37/3-~~CS~~ 7001 Poplar Avenue
(Takoma Park Historic District)

**HISTORIC AREA WORK
PERMIT**

SUBJECT: Historic Area Work Permit 37/03-03S

HISTORIC PRESERVATION COMMISSION STAFF REPORT

LOCATION OF WINDOW TO BE REPLACED

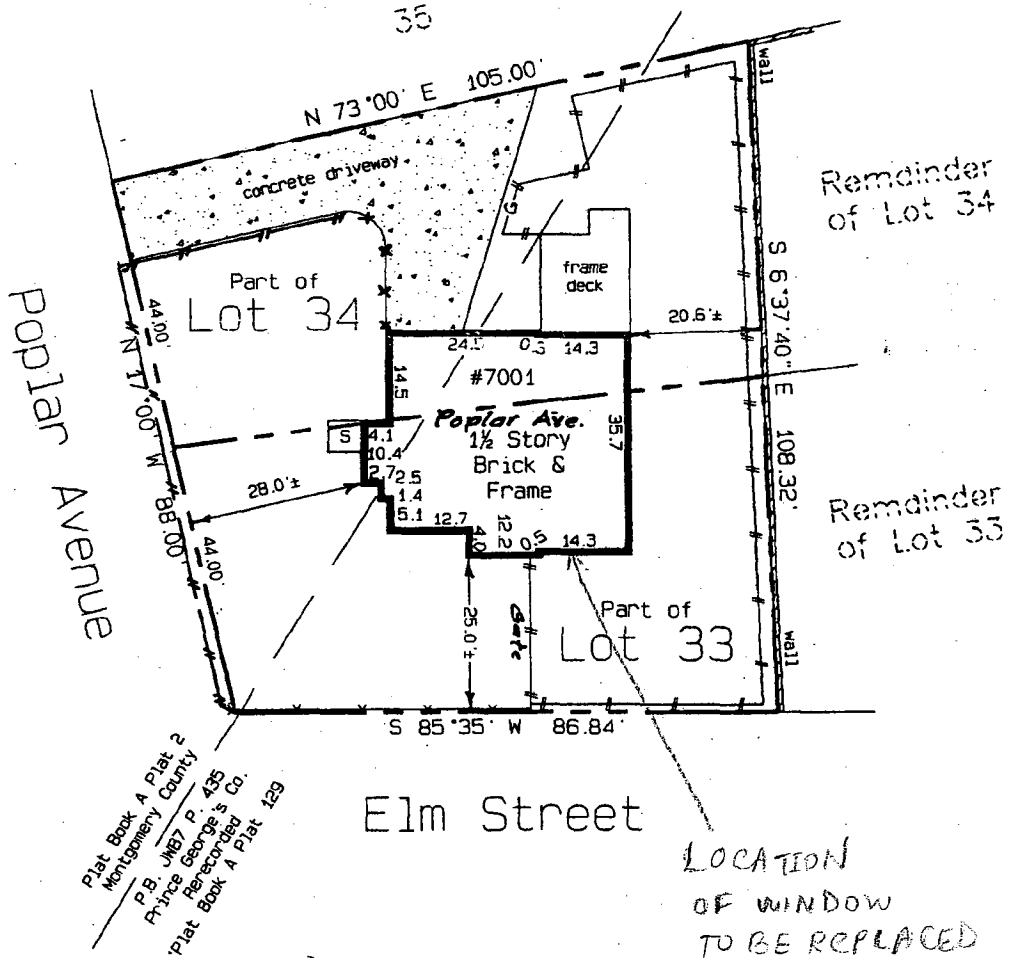
The applicant proposes to replace a picture window with two side 1/1 windows that faces Elm Avenue on an existing addition. Due to improper installation, the window needs to be replaced. The replacement window will be like the existing, though will be more energy-efficient as an aluminum-clad, double hung picture window.

Staff feels this project is approvable since the new window will be on an existing addition on a non-contributing resource. A wood fence surrounds the back yard of the property, making this window difficult to be viewed though is in keeping for a non-contributing resource on a new addition in the Takoma Park Historic District.

Staff recommends that the Commission *approve* the HAWP application as being consistent with Chapter 25A-8(b) 1:
